Planning for Exterior Work on the First Parish Church Portland, Maine

*Using Photographs
as Project Documentation*

A Preliminary Survey of the Building

Architect's Specifications for Project Work

Fig. 1. Deterioration of Roofing and Flashing.

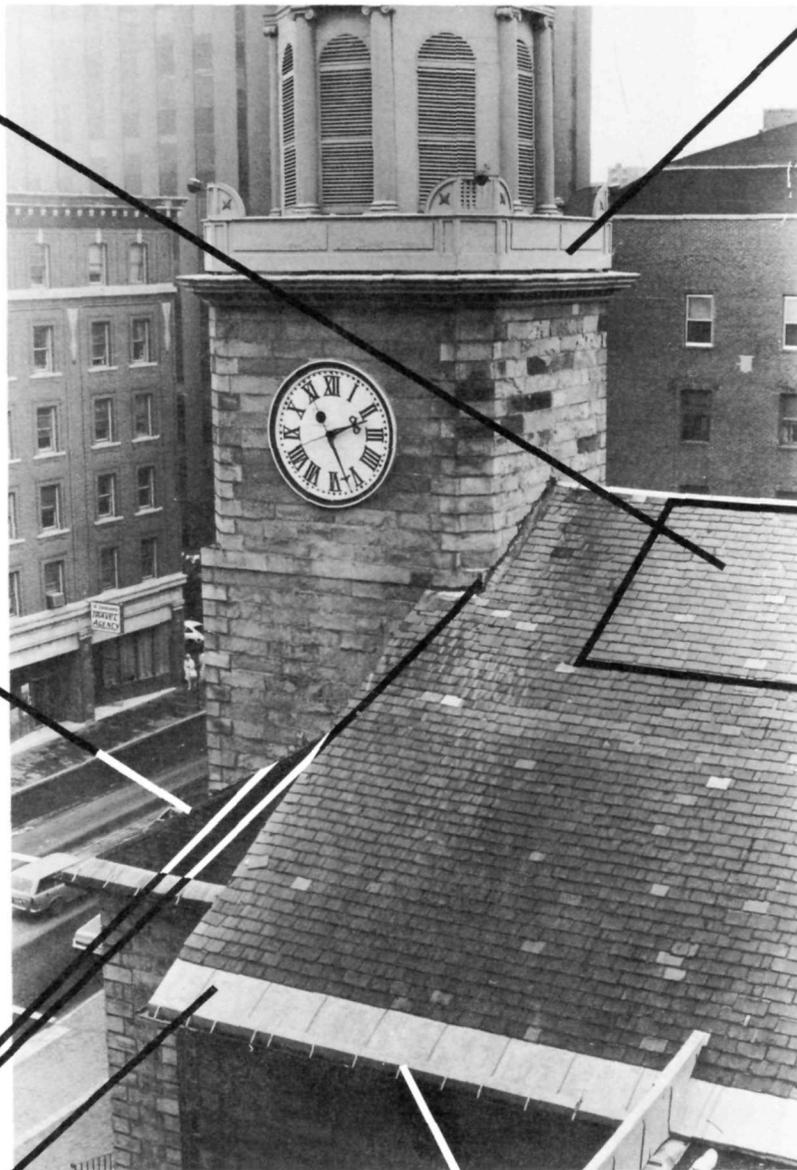
The existing slate roof has undergone numerous repairs over the years and therefore includes several different colors and sizes of slate. Most repairs have been limited to replacement of individual slates, except near the tower where an approximately 15' x 30' section was replaced with green slate (Fig. 1:a) in what was evidently an early, rather sizeable repair job on the main roof (see also Fig. C). Comparison of what we assume is an original slate with other slate samples indicates that the original slate was Welsh purple. We would estimate that only 20–30% of the existing slate can be re-used; the remaining 70–80% will have to be new slate. Obviously, when laying old and new slate side by side, a close color and size match are desirable. New slate will also be required for the two small hipped roof surfaces on either side of the tower, at present covered with black asphalt shingles (Fig. 1:b). Some holes, leaks and previous patching attempts are evident in the roof sheathing when viewed from the attic space. We estimate that 10–15% of the existing roof sheathing will have to be removed and replaced. Other areas of concern are the flashing and counter-flashing. Completely new flashing and counter-flashing will be required at the rear chimney and wherever any roof surface abuts the masonry tower (Fig. 1:c). The existing eave flashing appears to be in good condition (Fig. 1:d). A related flashing item is the re-hanging of several sections of gutter in order to facilitate better drainage (Fig. 1:e). A new metal ridge roll for the main roof and metal hip rolls for the two small hip roofs adjacent to the tower would also be required. Replacement of the existing attic ventilation system at the main roof ridge is also advisable.¹ Inspection of the existing copper roof at the base of the steeple (Fig. 1:f) for any cracks in the seams or joints is recommended. Several water-stained areas were noted in the sheathing beneath this surface which may indicate a leak. Re-soldering of suspect seams should eliminate any current water penetration (see Part 2 specifications, Slate Roofing 06500 and Flashing 07600).

f. INSPECT COPPER ROOF
AT BASE OF STEEPLE

a. APPROXIMATE 15'x30'
PATCH OF INAPPRO-
PRIATE GREEN
SLATE REQUIRING
TOTAL REPLACEMENT.
PATCH IS VISIBLE
IN 1865 PHOTO.

b. HIP ROOF SURFACES
COVERED IN INAP-
PROPRIATE BLACK
ASPHALT SHINGLES
REQUIRING TOTAL
REPLACEMENT

c. NEW FLASHING AND
COUNTERFLASHING
NECESSARY WHERE
ROOF SURFACES
ABUT MASONRY
TOWER

d. EXISTING EAVE FLASHING
IN GOOD CONDITION

e. SECTIONS OF GUTTER
NEED REHANGING

In reference to Fig. 1 (Deterioration of Roofing and Flashing), because no absolute photographic evidence of the 1826 roof ridge detail exists and

in view of the building's early roof repairs, another approach was selected in conjunction with the roofing contractor, Mr. C. Gordon LaRose, Portland Roofing Co., South Portland, Maine: a slate comb roof on the main roof and slate fantail hips on the two small roofs adjacent to the tower (see Part 2 specifications, Slate Roofing 06500).

Fig. 2. Below-grade Water Penetration at Basement Window Openings.

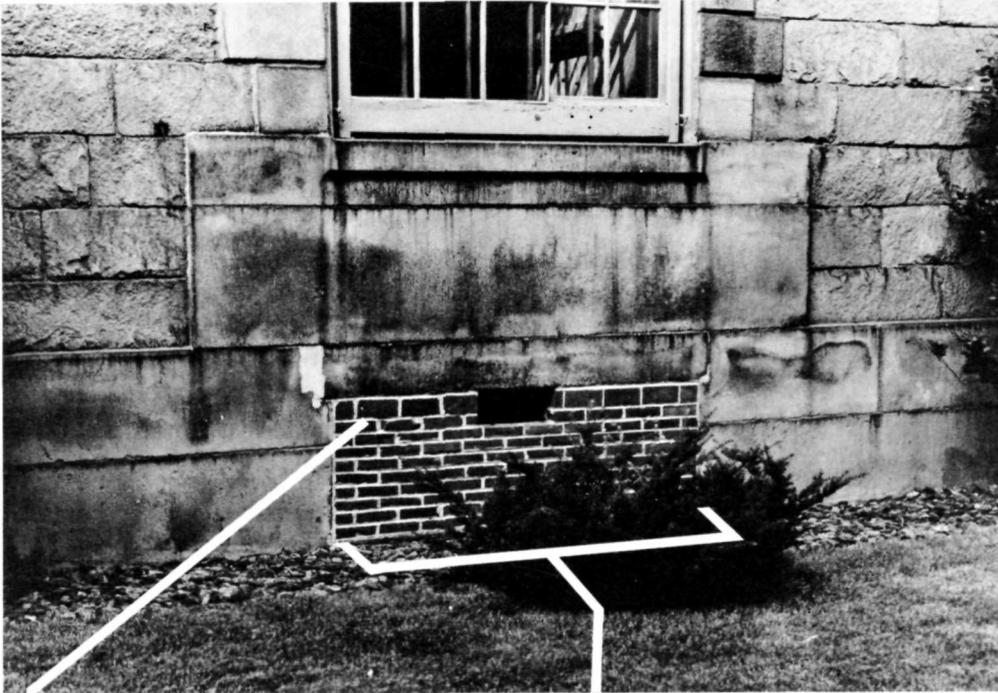
The three exterior wall penetrations at basement level were originally doorways to the three storage areas below the church. Within the recent past, each of these openings was closed by the insertion of concrete block and brick masonry, then backfilled with dirt (Fig. 2:a). It would appear, however, that no effort was made to mechanically seal the joints below-grade between the existing stone and the infill material. As a result, sizable amounts of water are penetrating the wall at isolated points below-grade. The water penetration is cause for concern. If the dampness is not removed through ventilation, it may well lead to future deterioration of both wood and masonry materials. We therefore recommend that the immediate area outside of each basement opening be excavated (Fig. 2:b) in order to install proper waterproofing membranes over the below-grade infill material and neighboring existing masonry (see Part 2 specifications, Dampproofing 07150 and related Site Improvements 02700).

a. ORIGINAL BASEMENT
DOOR OPENING FILLED
WITH CONCRETE BLOCK
AND BRICK - THEN
BACKFILLED WITH DIRT

b. BELOW GRADE AREA
TO BE EXCAVATED FOR
WATERPROOFING
TREATMENT

Fig. 3 Cornice Deterioration at the Urn Level of the Steeple.

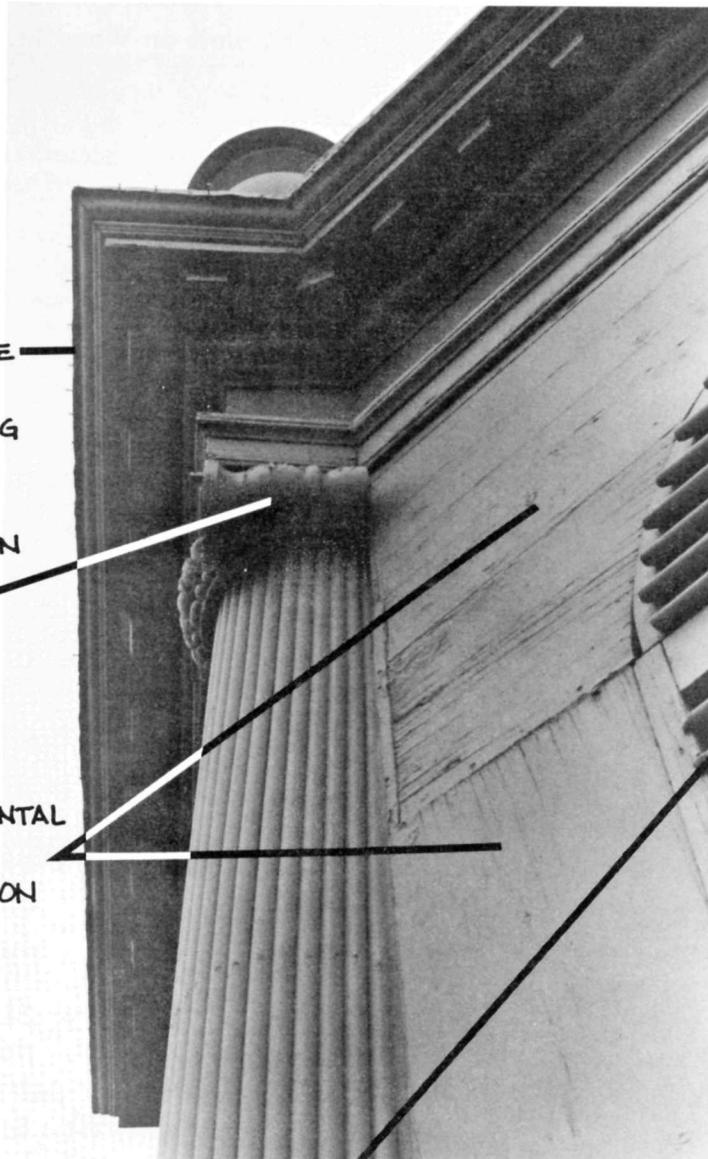
The cornice flashing, edge-nailed into the crown moulding (Fig. 3:a) is no longer serving its intended function of throwing water away from the cornice below. Instead, the many open nail holes provide an avenue for moisture penetration. Therefore, it is strongly recommended that all existing cornice flashing at this level be replaced and that all new flashing be detailed in such a manner as to avoid edge-nailing. Additional deterioration, including some large holes, is evident at several locations in the cornice soffit and should be repaired. Many of the Ionic column capitals also show weathering and deterioration at their upper surfaces (Fig. 3:b). Where possible, these areas should be consolidated and patched; the worst areas may require piecing-in of new wood. The vertical (Fig. 3:c) and horizontal sheathing (Fig. 3:d) needs a thorough scraping in preparation for painting, in addition to localized patching or caulking of open areas in the wood. The wood louvers (Fig. 3:e) require similar preparation prior to painting (see Part 2 specifications, Rough Carpentry 06100 and Flashing 07600).

3. DETERIORATED CORNICE
FLASHING IN NEED OF
REPAIR - EDGE NAILING
NOT RECOMMENDED

b. DETERIORATED COLUMN
CAPITALS NEEDING
CONSOLIDATION -
POSSIBLY PATCHING

c,d. VERTICAL AND HORIZONTAL
SIDING IN NEED OF
THOROUGH PREPARATION
FOR PAINTING

e. WOOD LOUVERS IN NEED OF
THOROUGH PREPARATION
FOR PAINTING

Fig. 7. Uneven Weathering of Mortar Joints.

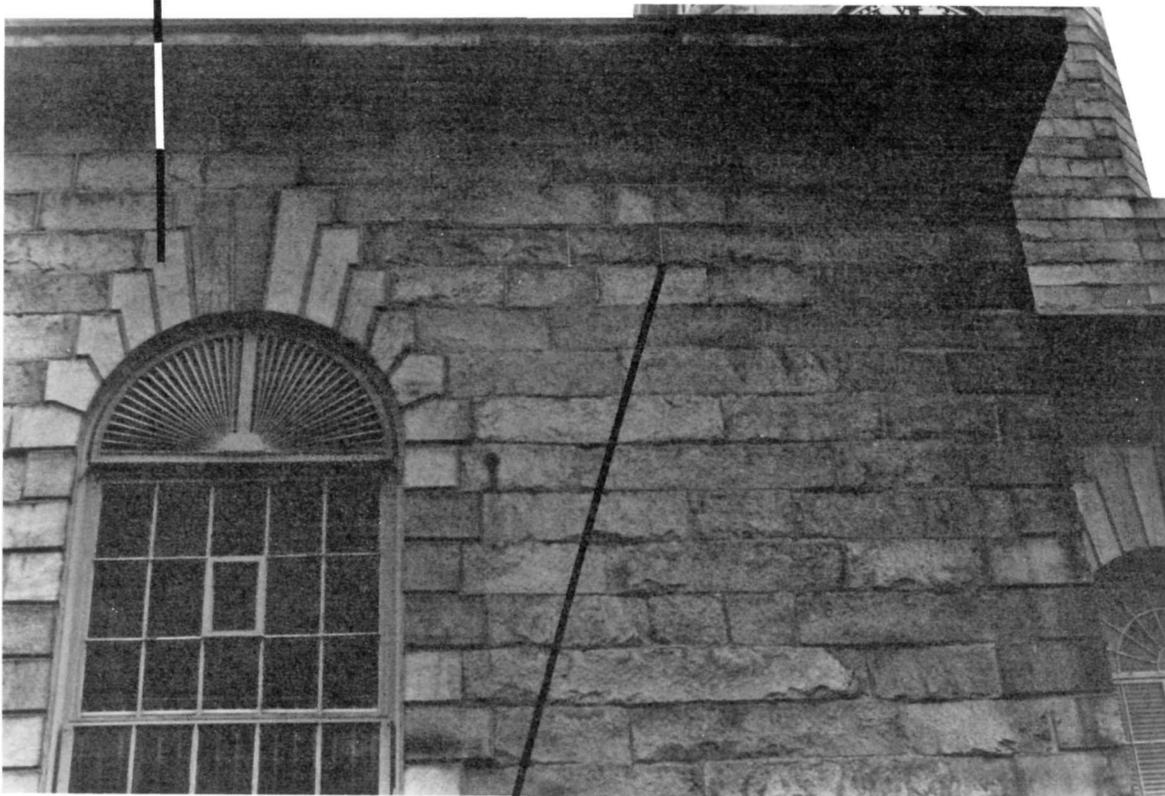
An examination of existing mortar joints revealed no obvious areas in immediate need of repointing. This is not to suggest that the walls are entirely intact, for our survey was made visually from the ground using a telephoto lens. Obviously, repointing has been undertaken in the past, as witnessed by the different mortar colors, textures, and joint profiles existing today. It is interesting to note raised mortar joints directly under the eaves at numerous locations. These raised joints appear lighter in color (Fig. 7:a) than the joints below (Fig. 7:b) and appear to have been tooled with the intent of giving the rock-faced ashlar a more regular appearance. It seems possible that because of the protective overhang of the eaves, these areas of mortar joints have suffered less from the action of weathering and attempts at repointing. It is recommended that before any major repointing work is undertaken in the future, a careful analysis be made of the existing joints below the eaves to determine both composition and profile of the mortar material.³

a. RAISED MORTAR JOINTS
DIRECTLY UNDER THE EAVES

b. UPPER MORTAR JOINTS OF
LIGHTER COLOR THAN THOSE
BELOW

NOTE: PRIOR TO ANY REPOINTING WORK,
AN ANALYSIS OF EXISTING MORTAR
COMPOSITION AND PROFILE IS
RECOMMENDED

No specifications have been provided for Fig. 7 (Uneven Weathering of Mortar Joints) and Fig. 8 (Exfoliation of Stone at Center Doorway) as per Mr. Hecker's recommendations, because further investigation and/or monitoring of these areas must be conducted prior to the development of additional items of work.

Fig. 8. Exfoliation of Stone at Center Doorway.

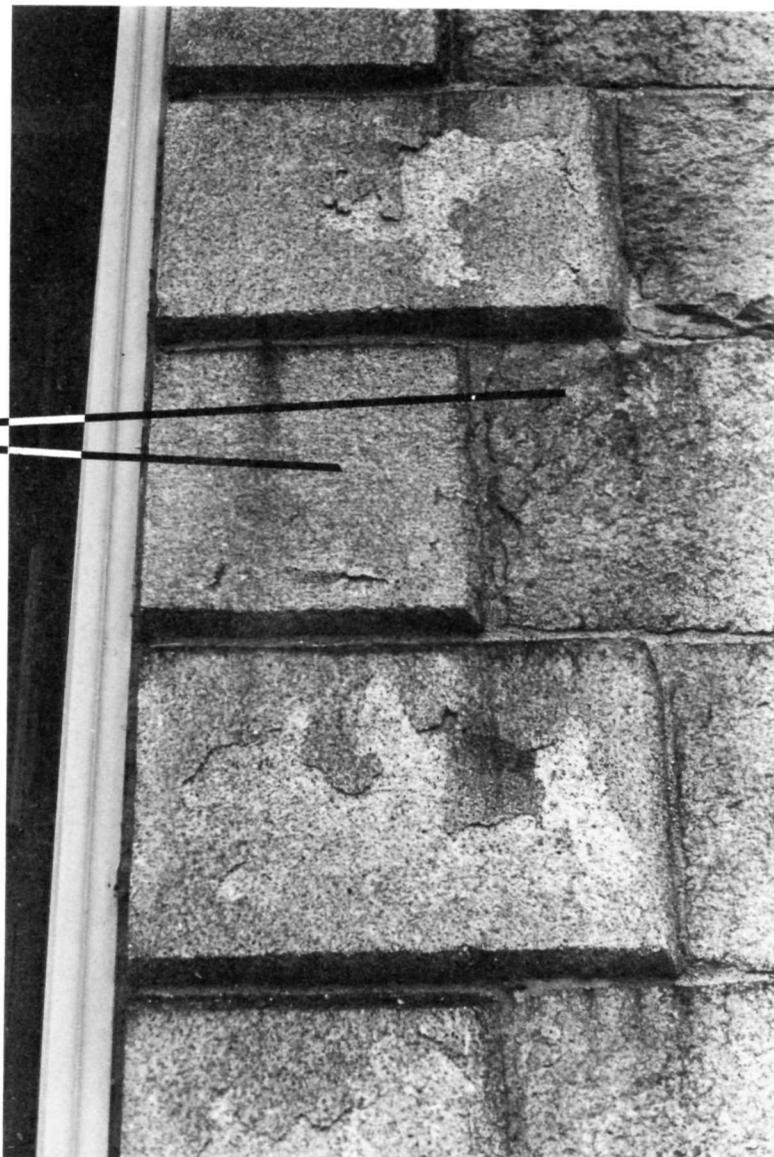
The weathering crust which has formed on the doorway quoins (Fig. 8:a) and adjacent masonry (Fig. 8:b) is exfoliating due to a combination of factors. The Portland urban environment imposes many stresses upon stone which include a higher level of sulfates and carbon dioxide in the atmosphere, frequent freeze-thaw cycles, street salting during the winter, a salt water environment, and winter and summer fog sequences. Unfortunately, little can be done to prevent additional weathering crusts from forming and exfoliating. Even in an ideal climate, most stones exhibit formation of a weathering crust, but at a much slower rate.

a,b WEATHERING CRUST
FORMED ON THE
DOORWAY QUOINS
AND ADJACENT
MASONRY
